SITE PLAN & ARCHITECTURAL COMMISSION AGENDA JULY 6, 2018

PROJECT Gordon Truck Center
Applicant: Gordon Truck Centers
Agent: Tom Sisul

FILE NO. AC-17-151

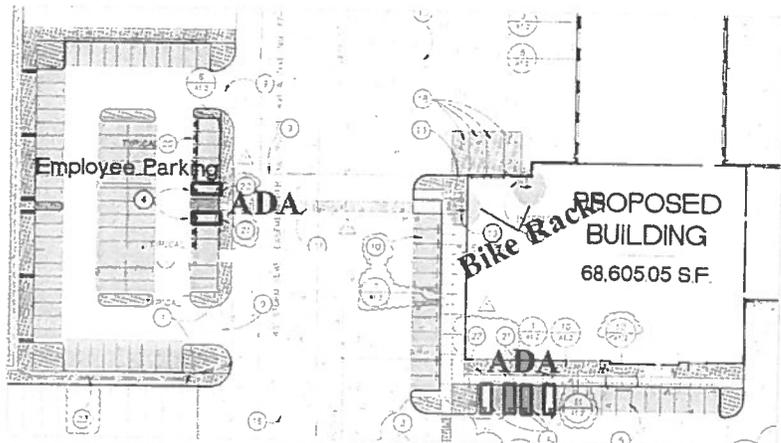
The submitted site plan identifies a total of 104 parking spaces, meeting the minimum/maximum parking standards as required per MLDC 10743-1, including the required number of accessible spaces; however, the number of bicycle spaces identified on the site plan is deficient 10 spaces as shown in the parking table above.

As a condition of approval, the applicant will be required to submit a revised site plan with their building permit submittals identifying a minimum of 21 bicycle parking spaces, as required per MLDC 10.748.

8. Submit a revised site plan identifying a total of 21 bicycle spaces as required per MLDC 10.748.
9. Submit a revised Planting Plan showing a total of 35 trees along the site's frontage of Table Rock Road, and 23 trees along the frontage of Biddle Road, consistent with the frontage landscaping requirements as per MLDC 10.797.

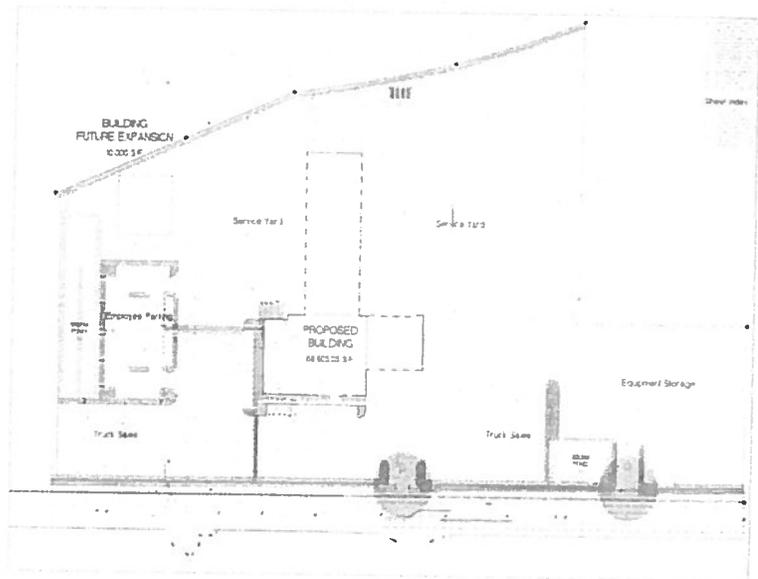
As shown in the Landscape Tables above, it can be found that the submitted Planting Plan (Exhibit N) meets and/or exceeds the parking area planter requirements per the Code; however, the number of trees shown along the site's frontage with Table Rock Road is deficient 10 trees, and deficient 6 trees along the site's frontage with Biddle Road.

As a condition of approval, the applicant will be required to submit a revised Planting Plan showing a total of 35 trees along the site's frontage of Table Rock Road, and 23 trees along the frontage of Biddle Road, consistent with the frontage landscaping requirements as required per MLDC 10.797, and prior to the issuance of building permits for vertical construction.
